Planning and Development Services
Arun District Council
Arun Civic Centre
Maltravers Road
Littlehampton
West Sussex
BN17 5LF

Developer Services
Southern Water
Sparrowgrove House
Sparrowgrove
Otterbourne
Hampshire
SO21 2SW

Proposal: Single storey front extension.
Site: 3 Manor Way, Elmer, PO22 6LA.
M/52/15/HH

Southern Water MapGuide Browser

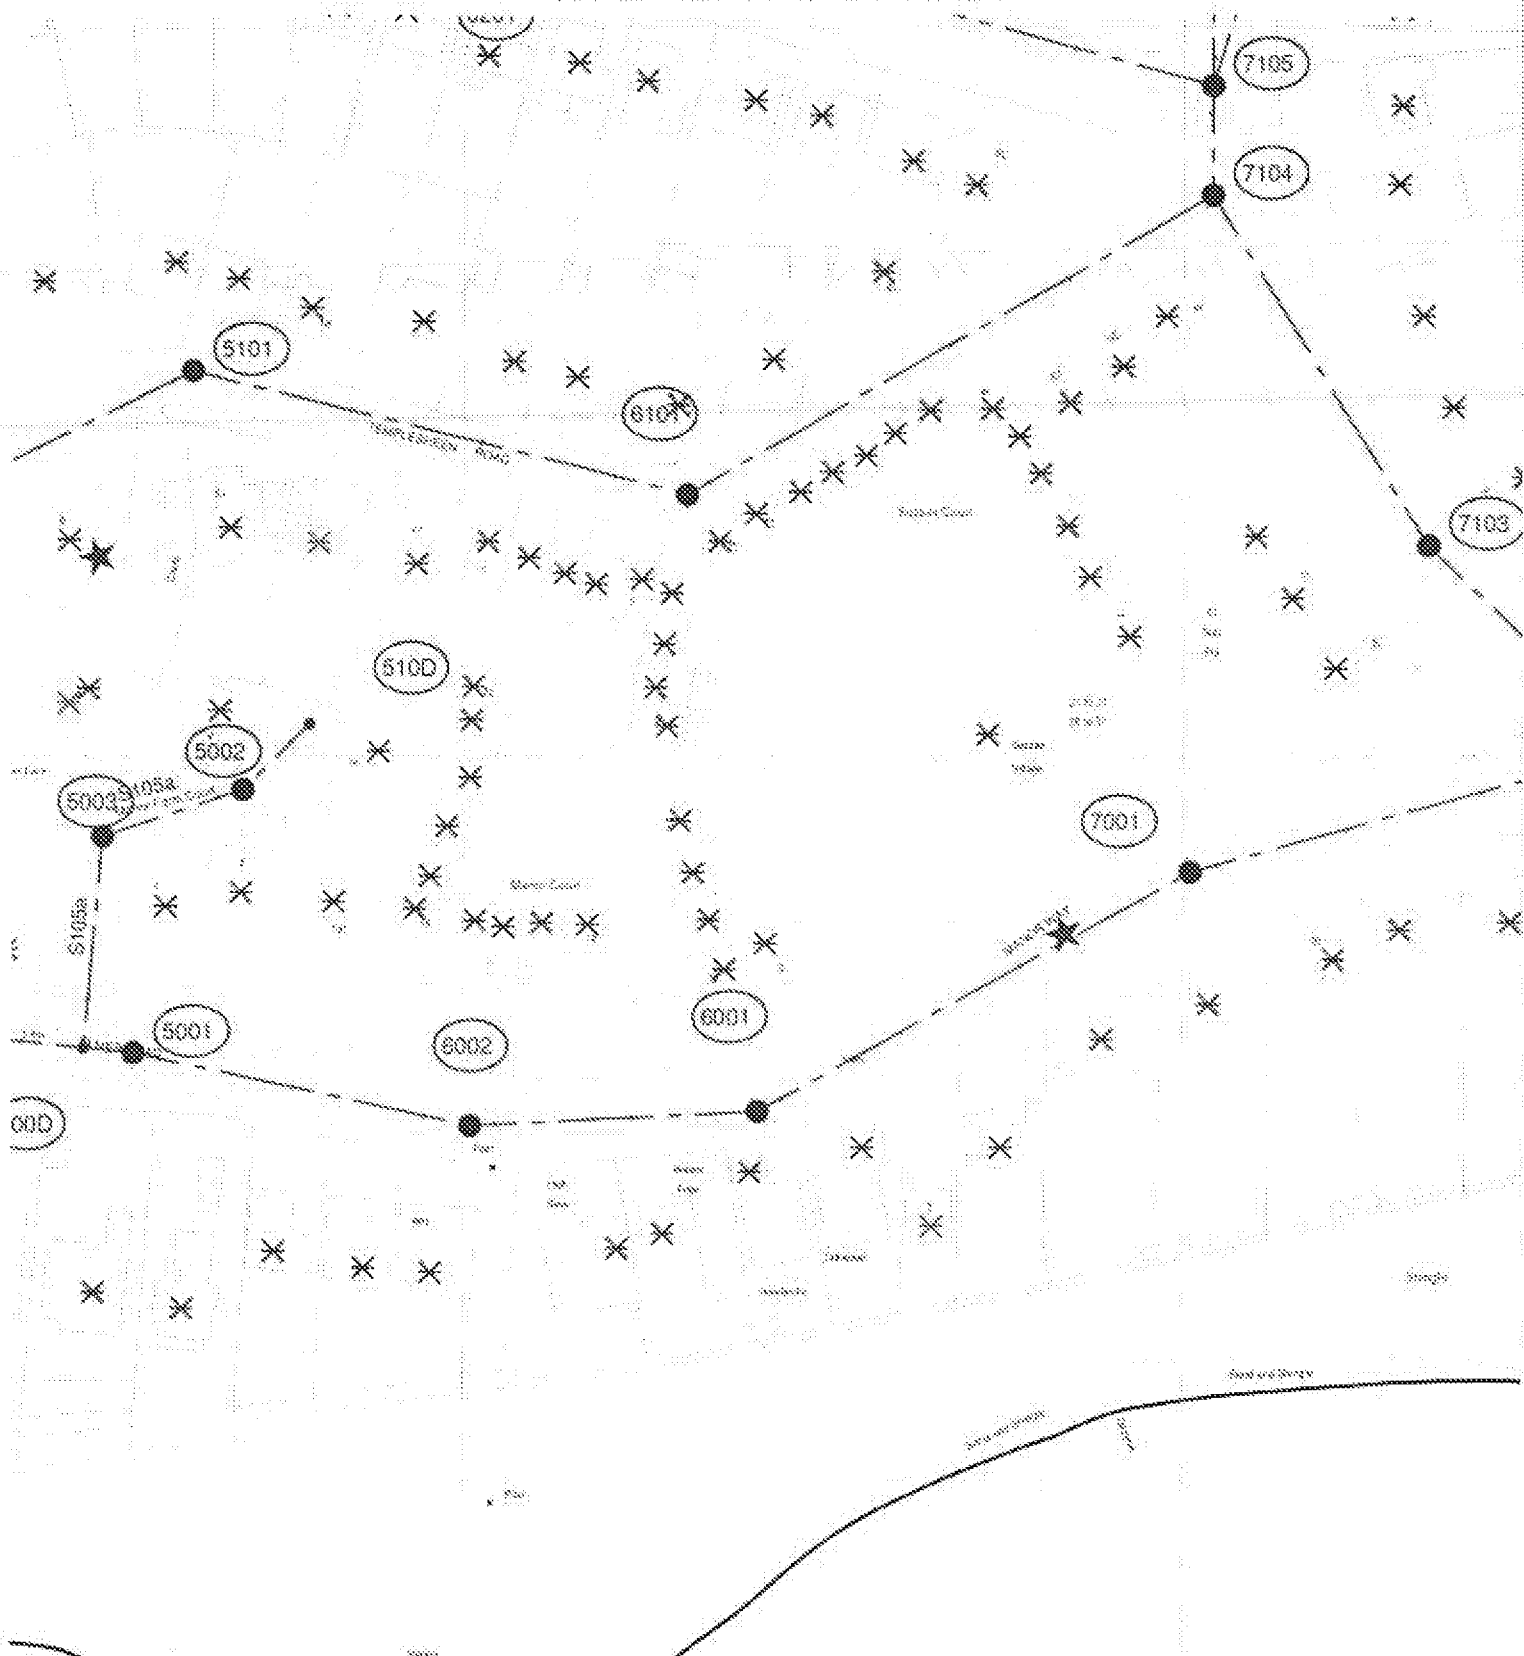
Our initial investigations indicate that there are no public surface water sewers in the area to serve this development. Alternative means of draining surface water from this development are required. This should not involve disposal to a public foul sewer.

Due to changes in legislation that came in to force on 1st October 2011 regarding the future ownership of sewers it is possible that a sewer now deemed to be public could be crossing the above property. Therefore, should any sewer be found during construction works, an investigation of the sewer will be required to ascertain its

condition, the number of properties served, and potential means of access before any further works commence on site.

The applicant is advised to discuss the matter further with Southern Water, Sparrowgrove House, Sparrowgrove, Otterbourne, Hampshire SO21 2SW (Tel: 0330 303 0119) or www.southernwater.co.uk.
